CH1: COMP pin voltage
CH2: CS pin voltage
CH3: trans current
CH4: Output current

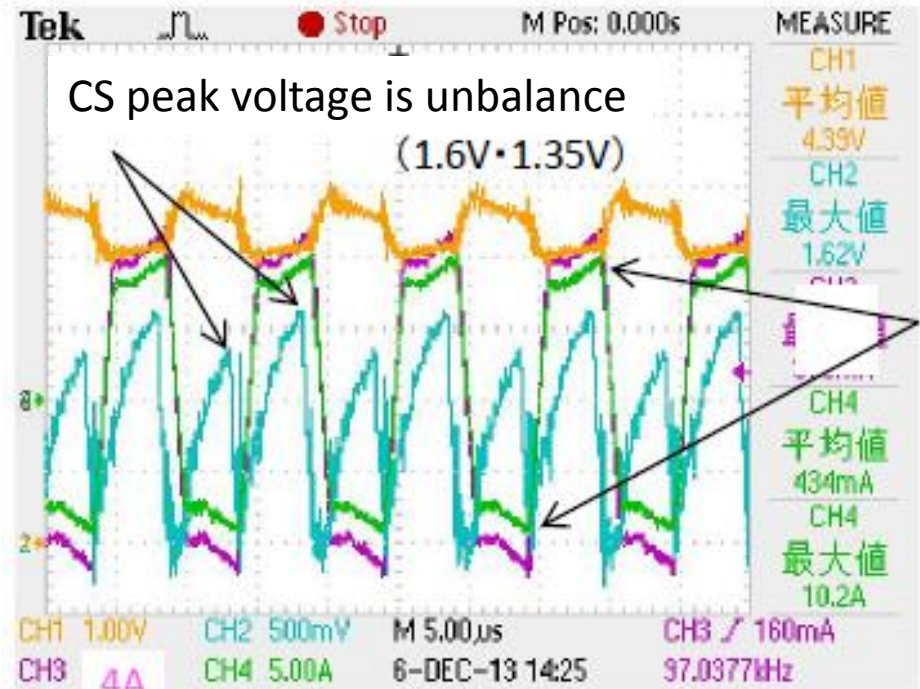
-I would like to know CS pin operation. Is this CS peak voltage correct ?

-If not please let me know the correct operation waveform of CS voltage and cause.
